Re: Florida Power & Light Company
Proposed Turkey Point Units 6 and 7
Docket Nos. 52-040 and 52-041
Response to NRC Request for Additional Information Letter No. 037
(eRAI 5896) SRP Section - 02.05.02 Vibratory Ground Motion

NRC RAI Letter No. PTN-RAI-LTR-037

SRP Section: 02.05.02 - Vibratory Ground Motion

NRC RAI Number: 02.05.02-2 (eRAI 5896)

Figure 12a. Caribbean 2.5Hz weighted mean attenuation curve for a magnitude 6 earthquake.

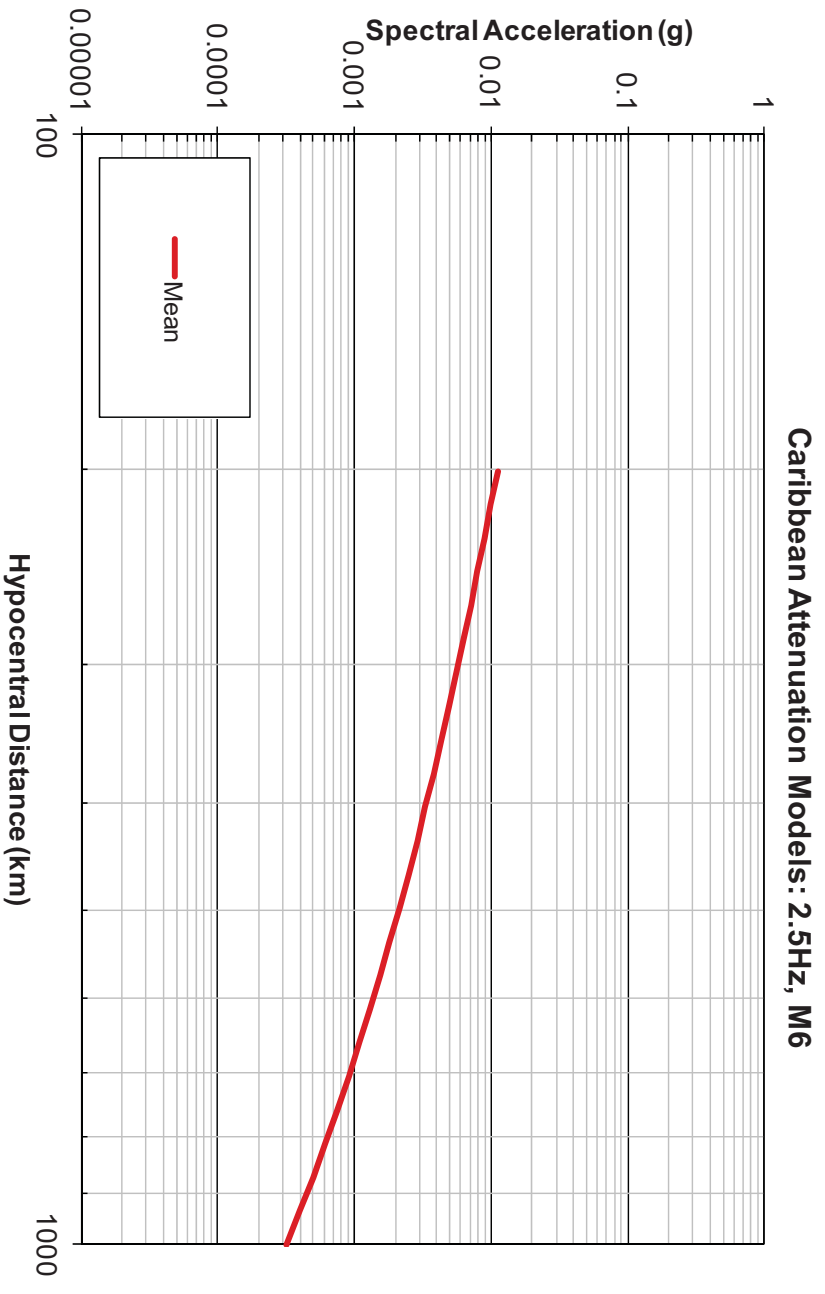
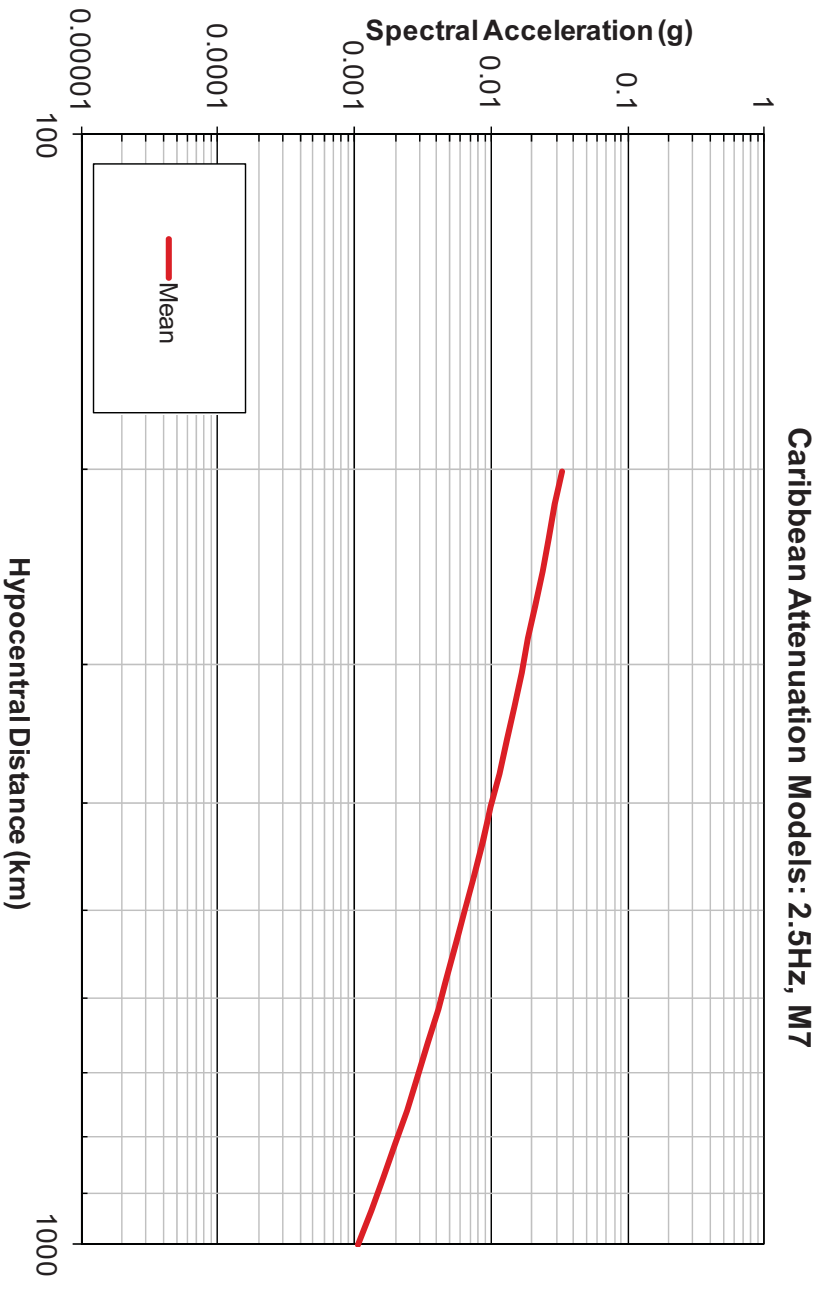
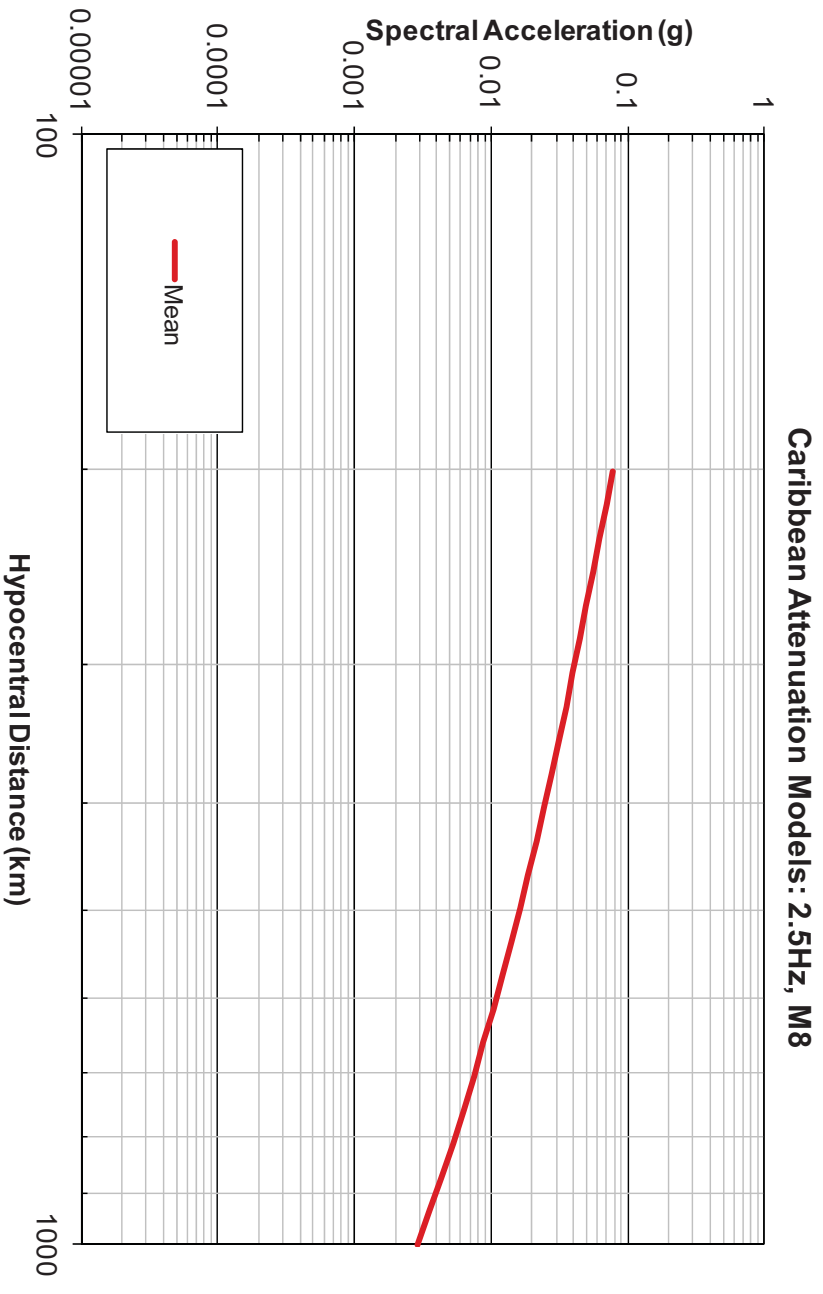
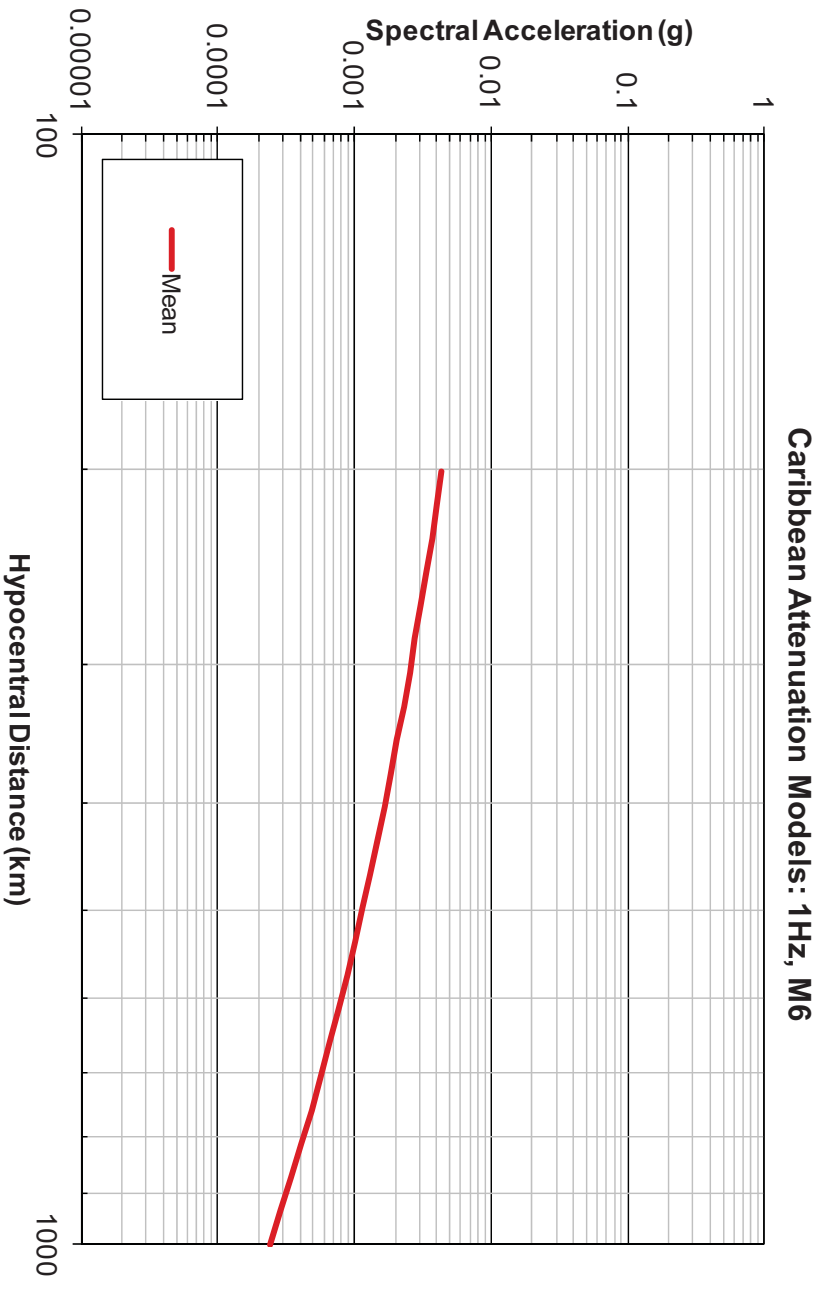
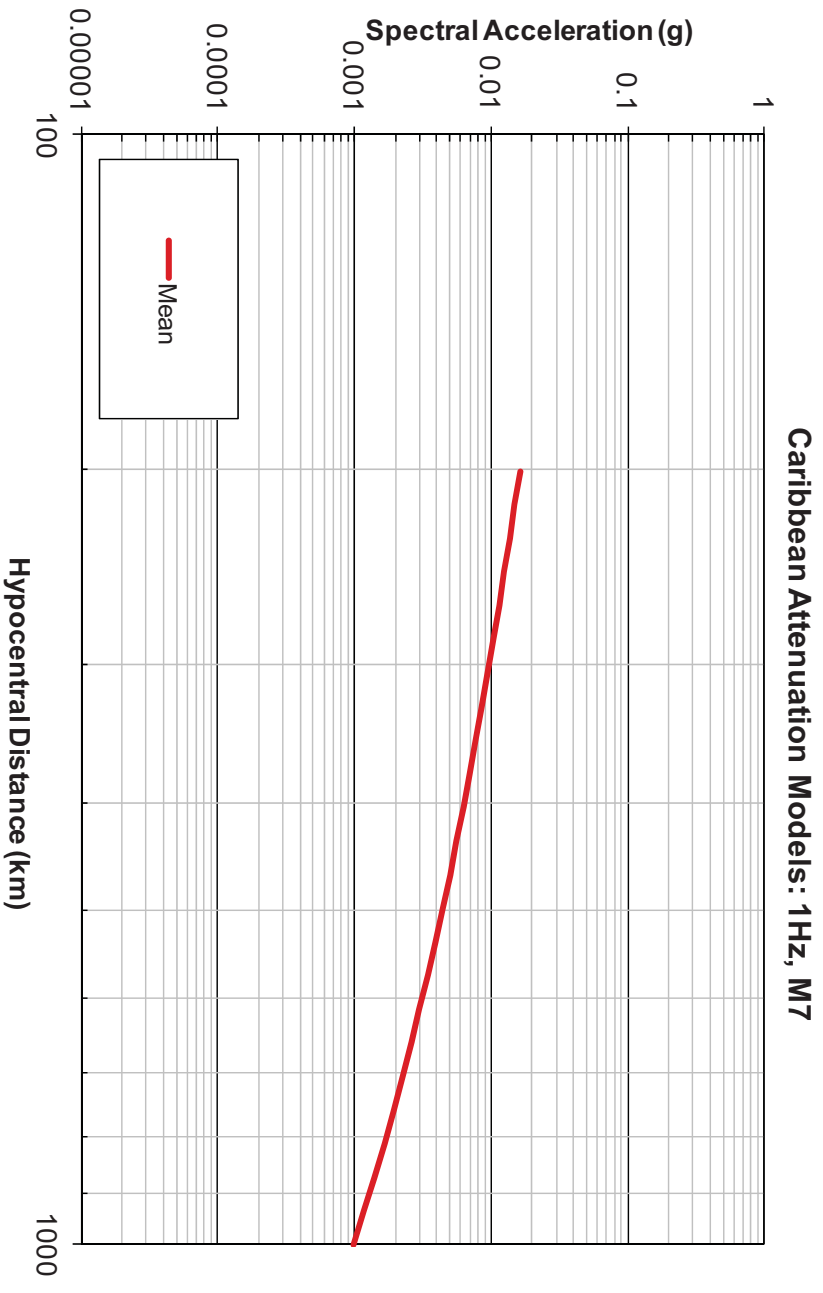
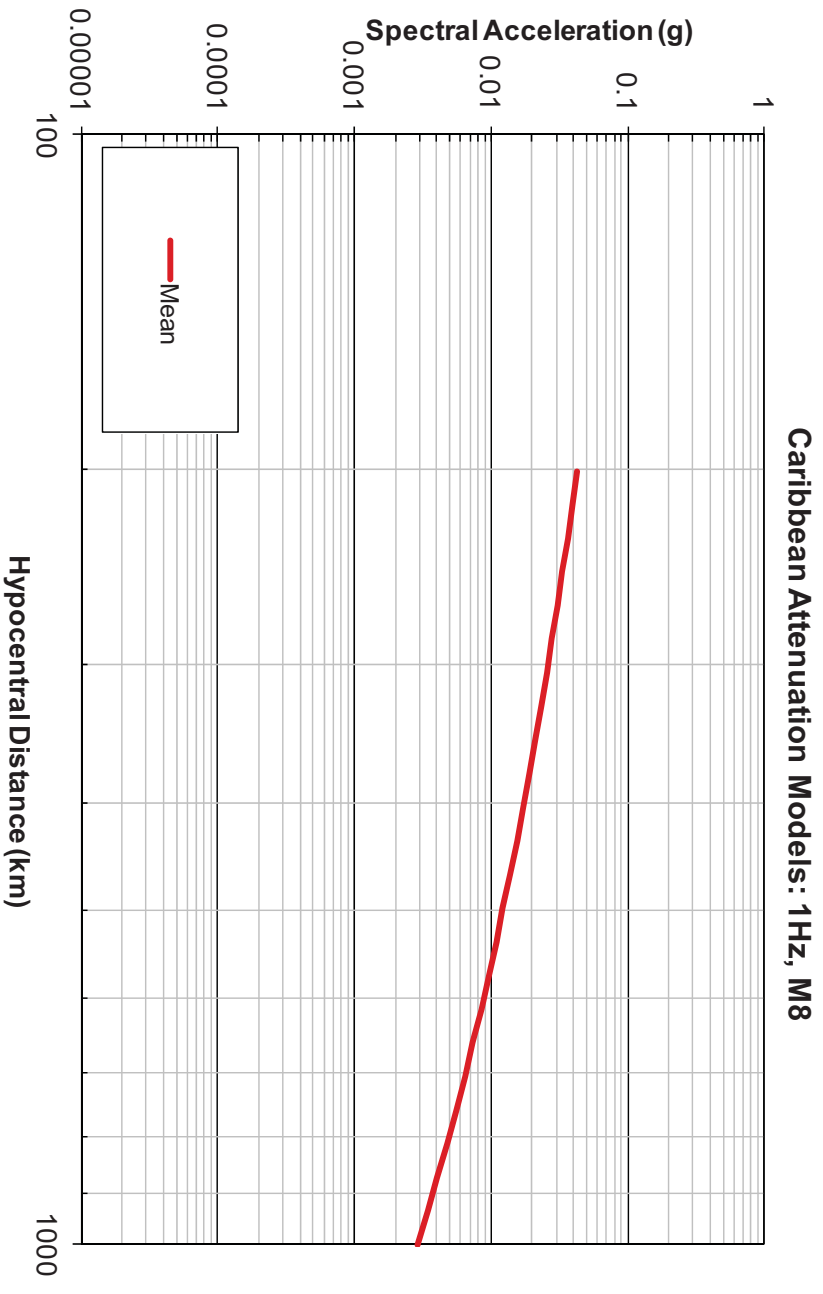
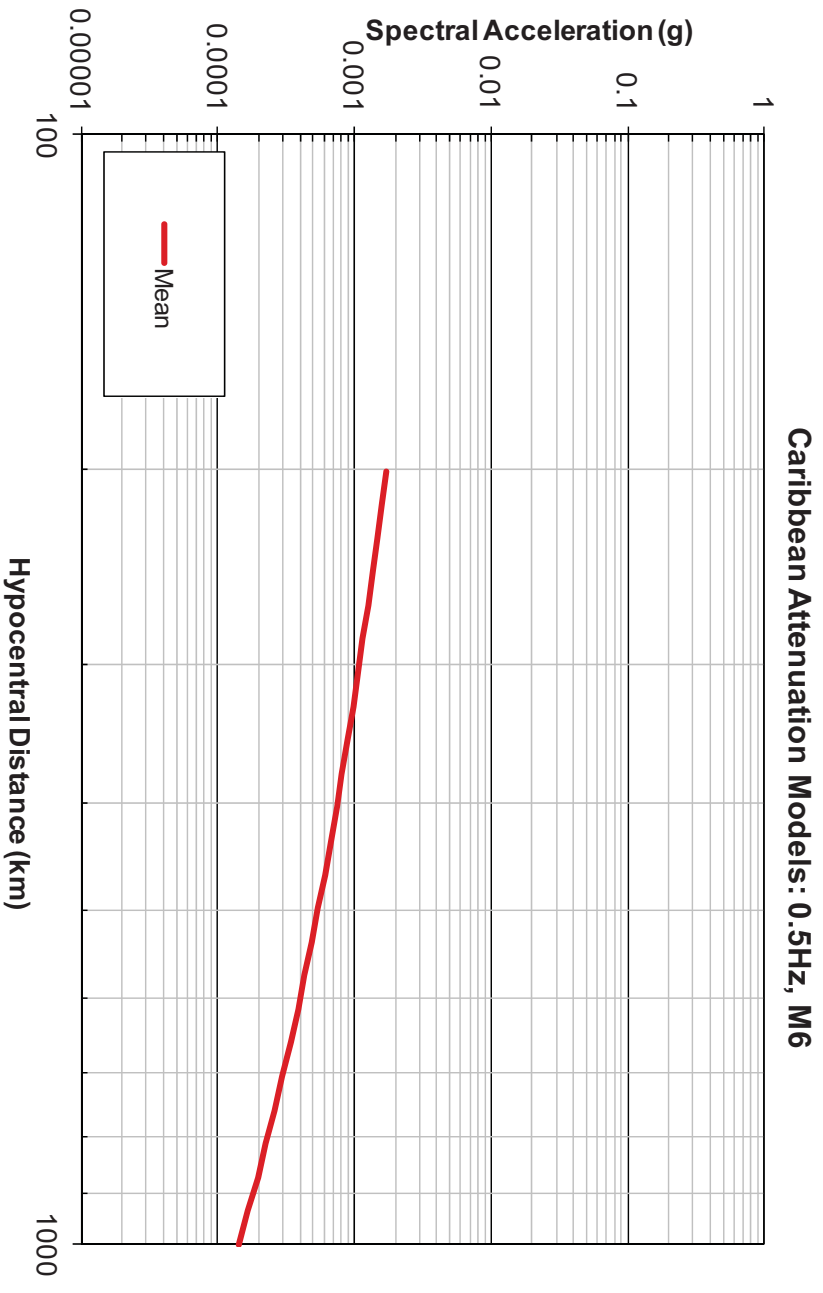
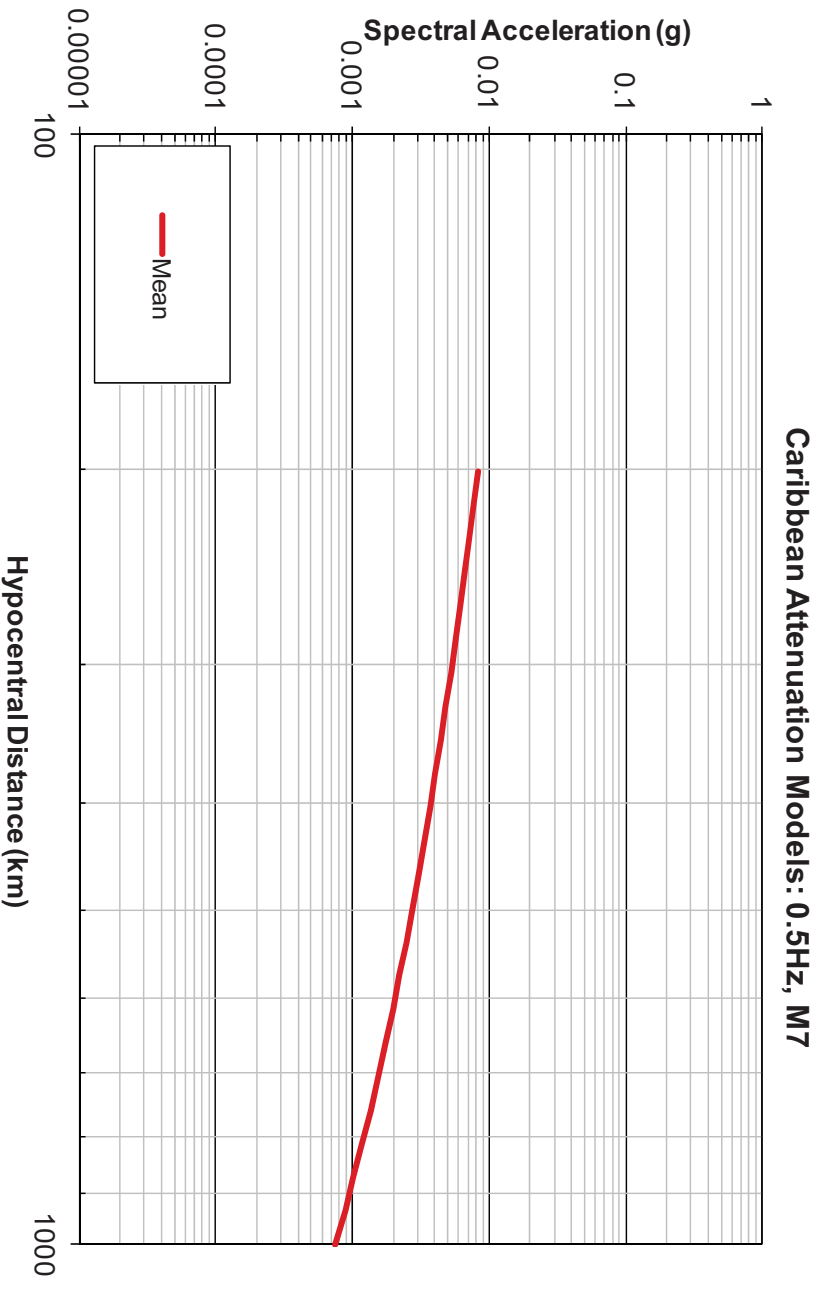
- d. In order for the staff to be able to compare the new Caribbean GMPEs with the 2004/2006 EPRI mid-continent GMPEs, please provide plots showing both ground motion models for earthquake magnitudes of 6.0, 7.0, and 8.0 in the distance range of 200 km to 1000 km at all seven frequencies defined in the EPRI 2004 and 2006 GMPEs.

Ground motion attenuation curve plots are provided for the EPRI (FSAR References 242 and 203) and Caribbean ground motion prediction equations (GMPEs). Note that EPRI (FSAR Reference 203) is only a recommendation for the associated aleatory uncertainty and therefore does not impact the comparison plots of the weighted mean ground motion

attenuation curve. The plotted mean attenuation curve is the weighted mean of the individual median attenuation curves as defined in EPRI (FSAR Reference 242). These attenuation plots are provided for three specific moment magnitude (M_w) values: 6, 7, and 8 for distances between 200 km and 1,000 km. Note that the EPRI (FSAR Reference 242) ground motion attenuation model is defined as a function of epicentral distance, whereas the Caribbean ground motion attenuation model is defined as a function of hypocentral distance. However, because the closest distance is 200 km, the difference between the epicentral and hypocentral distances would be less than 1% for a typical crustal depth of 10 km and even smaller for larger distances out to 1,000 km.

The weighted mean ground motion attenuation curves for the EPRI (FSAR Reference 242) model are given in Figures 1 through 7 for the three magnitudes and seven spectral frequencies requested in the RAI. The weighted mean Caribbean ground motion attenuation curve plots for the same suite of magnitudes, distances, and spectral frequencies are shown in Figures 8 through 14.
